Section 4
DIRECTION-FINDING EQUIPMENT
D Series

SECTION 4. DIRECTION-FINDING EQUIPMENT

FIGURE 1.—Schematic of circuit.

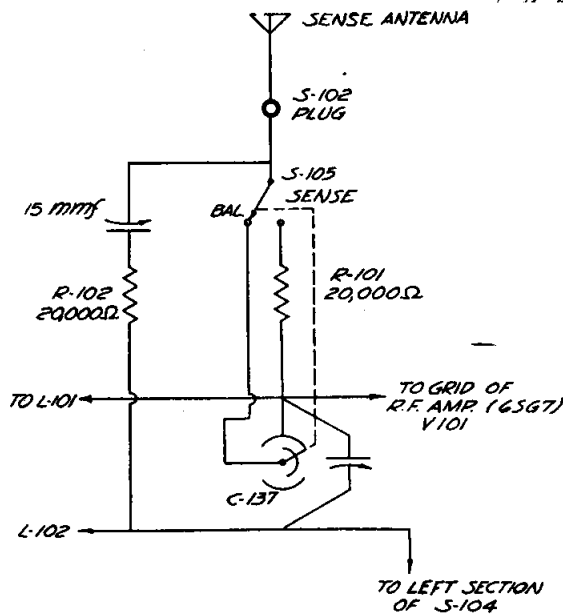
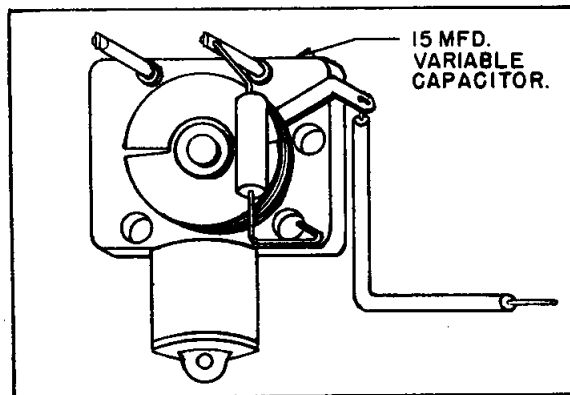
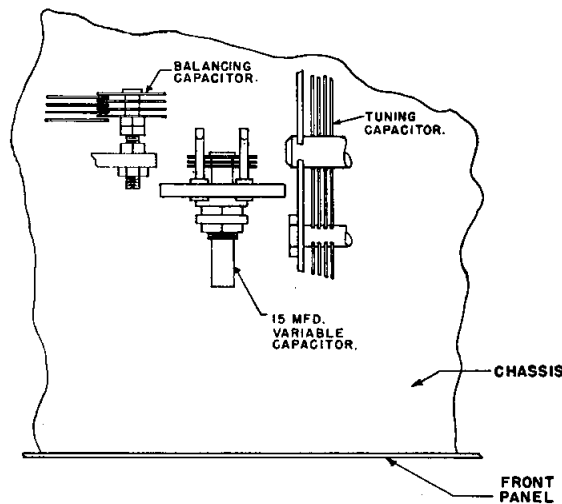
This fault has been corrected by installing a 15-micromicrofarad variable capacitor and a 20,000-ohm $\frac{1}{2}$ -watt resistor between the antenna and the tuning capacitor forming a balanced bridge circuit (see Figure 1). The stray in-phase component produced by the capacitance between the antenna and the sense resistor R-101 through

switch S-105 is opposed by the potential introduced by the 15-mmfd. variable capacitor and the 20,000-ohm resistor, causing these potentials to cancel. This in turn balances the loop circuit. It should be noticed in Figure 1 that R-102 must be of the same value as R-101 in order for the circuit to balance.

The 15-mmfd. variable capacitor and the 20,000-ohm $\frac{1}{2}$ -watt resistor should be mounted on an insulator pedestal as shown in Figure 2 and

should be mounted approximately three inches back of the front panel of the case on the top side of the chassis midway between the balance capacitor and the tuning capacitor as shown in Figure 3. The rotor is connected to the antenna terminal of the sense balance switch and the free end of

the resistor is soldered to the forward side of the forward section of the balance capacitor stator.

FIGURE 1.—Terminal and tap arrangement of loading coil.

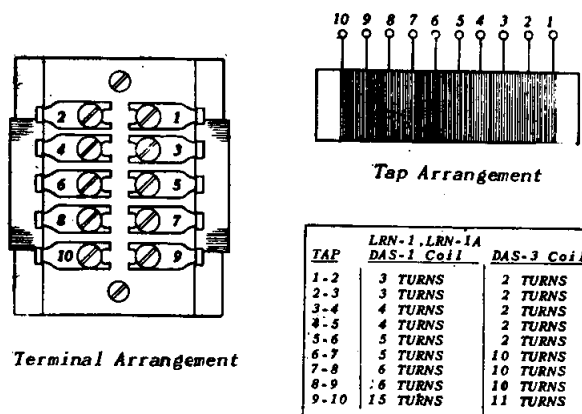
(1) Improper adjustment of the loading coil. In many instances the entire number of coil turns is used (from tap 1 to tap 10), and no attempt has been made to adjust the number of turns (by selecting appropriate taps) for maximum signal strength. The loading coil should be connected so that it is in series with the antenna lead-in and the center conductor of the coaxial cable. The active number of turns is the number between the two taps to which the two flexible leads (one from the antenna, one from the coaxial cable center conductor) connect. The tap arrangement is somewhat peculiar, as shown in figure 1, and should be carefully noted.

FIGURE 1.—Schematic for field change No. 4 for LRN-1 A.

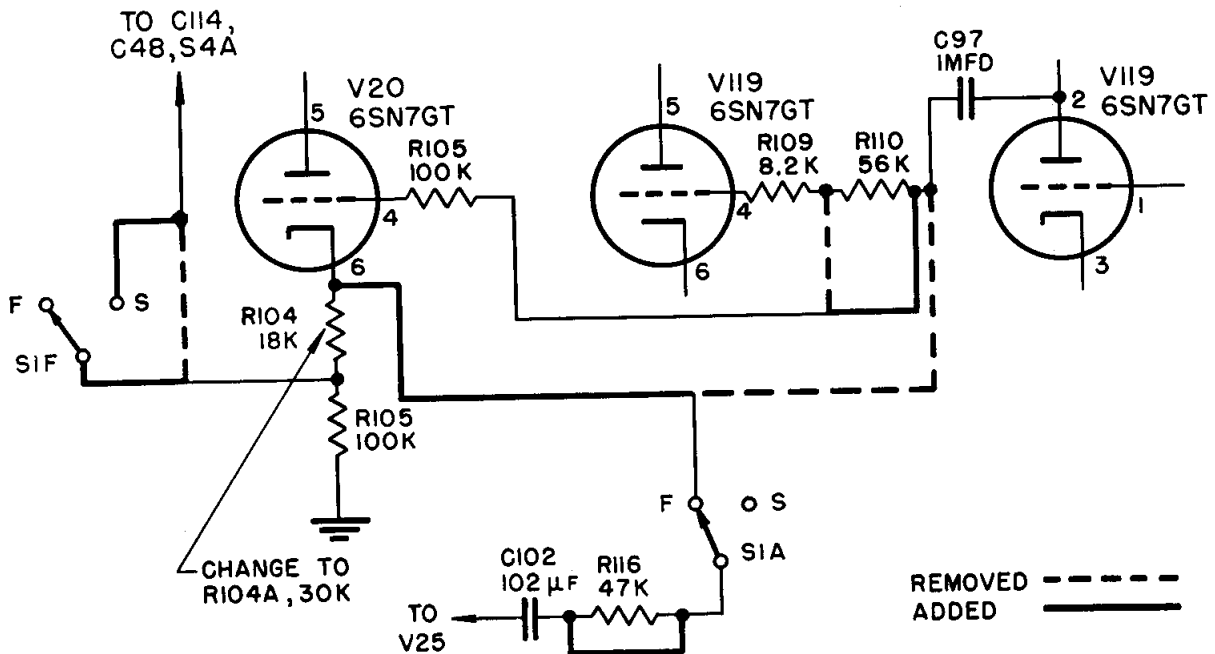
The purpose of the change is to provide a CRT grid driver circuit which is not adversely

In order to drive the intensifier voltage below the present level which is satisfactory with good cathode-ray-tubes, a low impedance driver is necessary in place of the original drive from the "on" tube of the pedestal generator delay multivibrator. The cathode follower, terminals 4, 5, and 6 of the V-20, which normally serves to apply the pedestal-creating voltage to the vertical plates, is admirably suited to this purpose and is not necessary during the fast sweeps. Therefore, this design modification simply involves borrowing this cathode follower for an

intensifier driver during the fast sweeps. Extra connections to existing switches are used, one existing resistor (R116) is shorted out, and one new resistor is needed (30K, 1/2-watt) to replace R104.

Referring to the accompanying diagram (Figure 1), the five steps necessary to accomplish this modification are as follows:

- (1) Disconnect the wire at the junction of R110 and C97 that runs from the pedestal generator V-19 to switch S1A, and connect it to pin 6 of V-20, the cathode follower.
- (2) Disconnect the wire at the junction of R109 and R110 which runs through R105 to pin 4 of V-20, and connect it to the junction of R110 and C97.
- (3) Short circuit R116.
- (4) Replace R104 with a 30K 1/2-watt resistor, R104A.
- (5) From the junction of R103 and R104A connect to an unused section of S1 (the slow-fast sweep switch) in such a way that the circuit will be closed back to C114 in the slow sweep position and open during the fast sweeps.

An emergency cure for the bright spots can be effected by connecting a resistor of 2 to 5 megohms from pin 5 of V-35 to the junction of

C-77 and R-120 in the negative high voltage power supply. By increasing the negative bias on the grid in this way, the tube will remain cut off during the part of the cycle when the fast sweep is not sweeping, and the bright spots will be eliminated, but the changes above are preferable. (This change was originally published as a supplement to the LRN-1A instruction book.—11/1/45.)

FIGURE 22.—Installation of a mounting board in field change No. 6-DAS-1, -3.

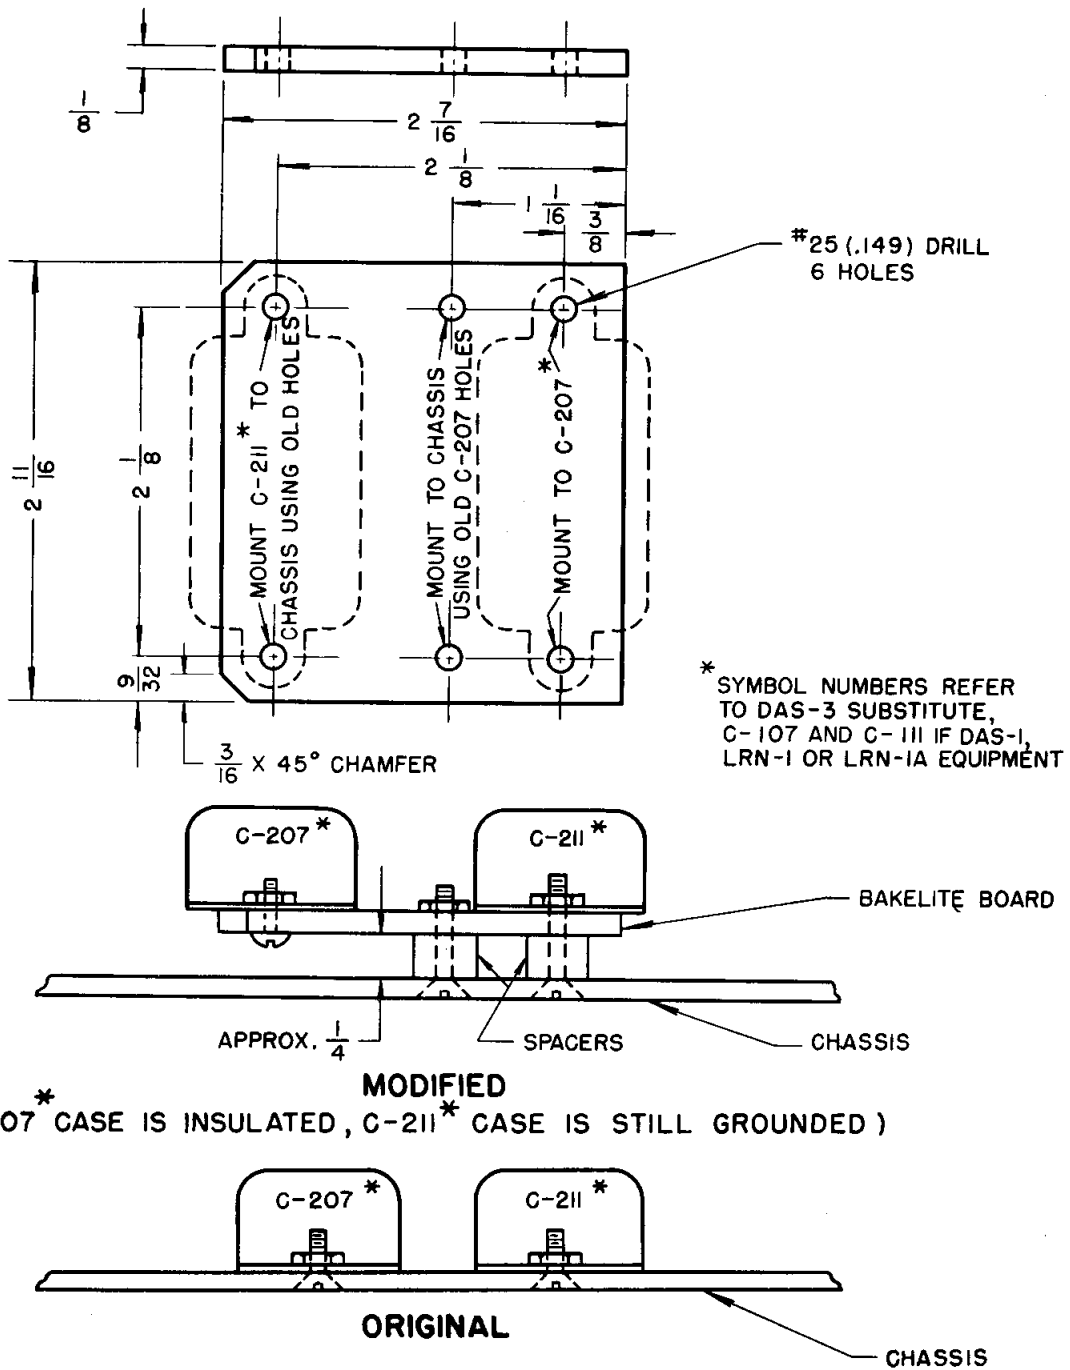
Indistinctness of the upper left dot in the No. 2 test jack pattern may occur if C107 in DAS-1 or C207 in DAS-3 has a high capacity to ground. Different makes of capacitors vary greatly in this respect. The difficulty can be completely eliminated by insulating the case of C107 or C207 from ground by means of a mounting board of bakelite or other nonconducting material. As a convenience both C107 or C207 and C111 or C211 should be mounted on the board as shown in diagram of figure 1 but only C107 or C207 is to be insulated from ground. The spacers may be of any convenient material, either metal or nonconducting and the dimensions are not critical. The result of these changes is to reduce the slow sweep retrace time so that the dot formerly partially lost in the retrace can be clearly seen.

Material required: Small piece of insulating board per drawing.

FIGURE 1.

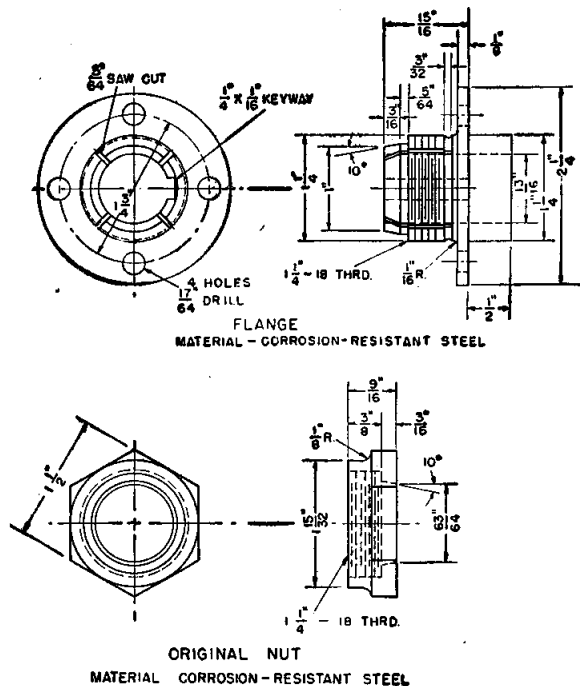
This item replaces an item which described a method of repairing Model DBM and DBM-1 antenna spinner bases which have broken hubs. The method has been found to be unsatisfactory due to the excessive stress placed on the four mounting screws holding the new hub.

An improved type of hub is shown in Figure 1. It differs from the original modification by the addition of the $1\frac{1}{4}$ " collar and a larger flange. It should be machined from corrosion resistant steel. The nut shown is the original

locking nut. The spinner base must be bored to take the $1\frac{1}{4}$ " collar of the hub and then counterbored $\frac{1}{8}$ " for the $2\frac{1}{4}$ " flange. Four matching holes must be drilled in the spinner base and the hub attached by means of four screws, nuts, and lockwashers. Whenever possible, this repair should be effected rather than the replacement of the entire unit. 10/1/50.
